MIL-G-62061A(AT)
AMENDMENT 3
31 March 1980
SUPERSEDING
AMENDMENT 2
28 February 1978

MILITARY SPECIFICATION

GENERATOR, ENGINE ACCESSORY, 28 VOLT DC,
RATED OUTPUT 300 AMPS

This amendment forms a part of Military Specification MIL-G-62061A(AT), dated 14 December 1973.

FIGURE 3. Generator interpole voltage drop at 390 amp load vs generator cooling air temperature.

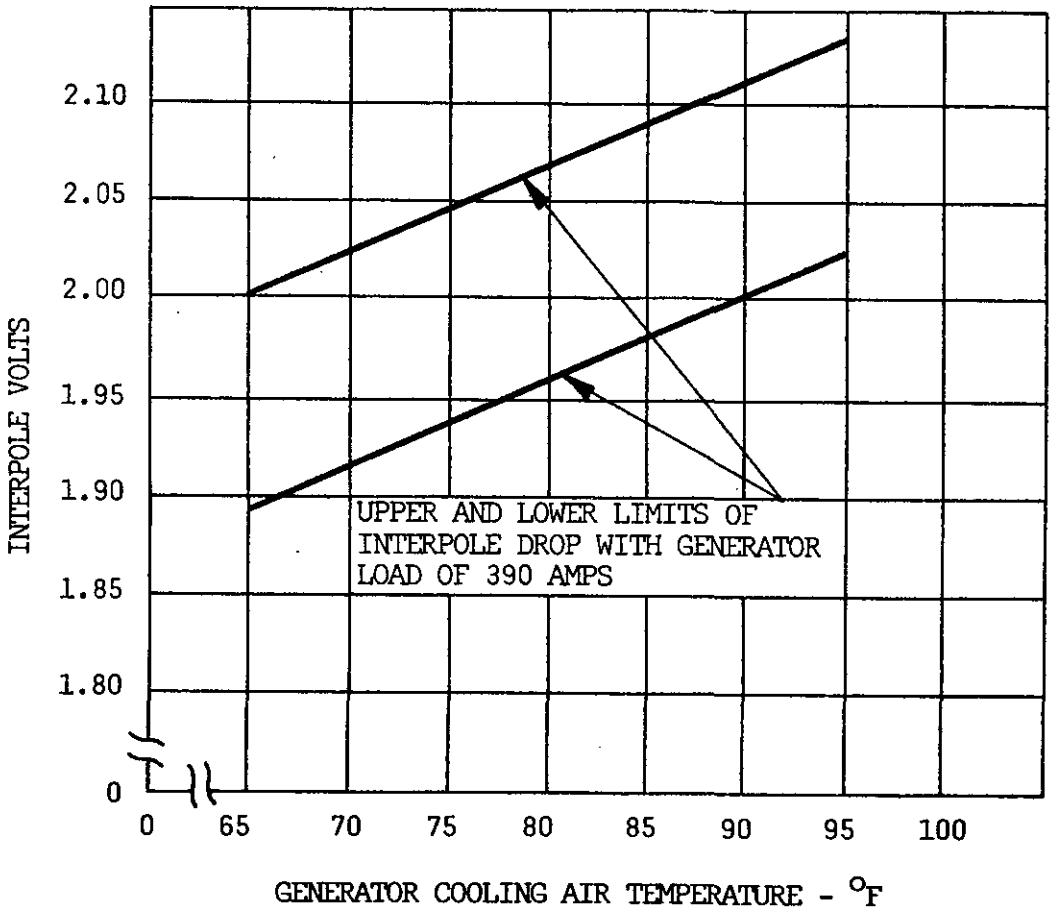
3.3.6, line 3, delete "shall conform to the curve shown on drawing 10898795" and substitute "shall conform to limits shown on figure 3."

4.6.7.2 Test operation. To determine conformance to 3.3.6, the generator shall be operated with a separately excited field (from a constant power supply) at 5500 rpm with a resistive load of 390 amperes at 28 volts until conditions temperature stabilize. After stabilization, record interpole voltage, load current, terminal voltage and cooling-air temperature. Using figure 3, find cooling-air temperature equivalent to that recorded. The recorded interpole voltage of the generator must fall within the limits (figure 3) on the ordinate determined by the cooling-air temperature."
